Amendments to the Drawings:

Appl. No. 10/713,040
Art Unit 3618
Customer No. 37833
Confirmation No. 1144
Annotated Sheet Showing Changes

Fig. 1

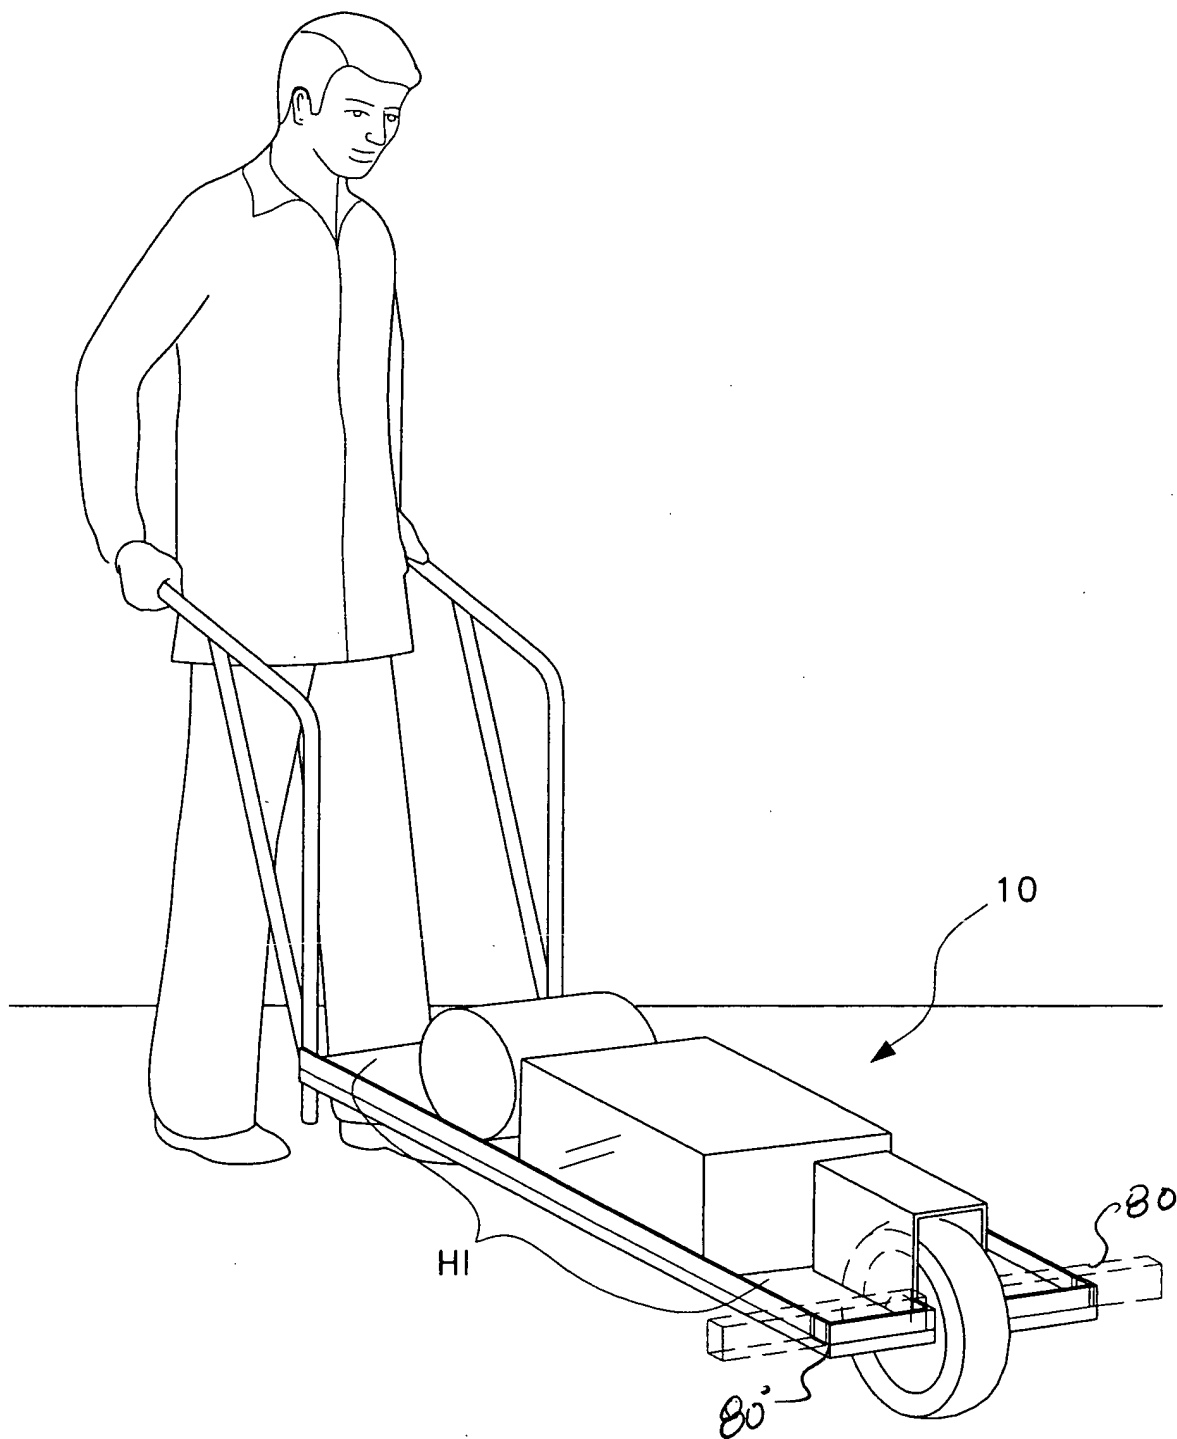
The Examiner objected to the drawings under 37 C.F.R. § 1.83(a) because certain claimed features were not shown in the drawings. Specifically, the 3" high board of Claim 2, and the fitted groove of the horizontal bars of Claim 12 have not been shown. Applicant has canceled Claim 2, thus rendering this objection moot. The drawings have been corrected to show the fitted grooves 80' (see corrected Fig. 1). Applicant submits that this

A proposed drawing change is submitted herewith. Proposed changes are shown in red. The attached sheet of drawings includes changes to Fig. 1. This sheet, which includes Fig. 1, replaces the original sheet including Fig. 1. In Fig. 1, reference characters -- 80 -- (designating the horizontal bar) and -- 80' -- (designating the slot) have been added.
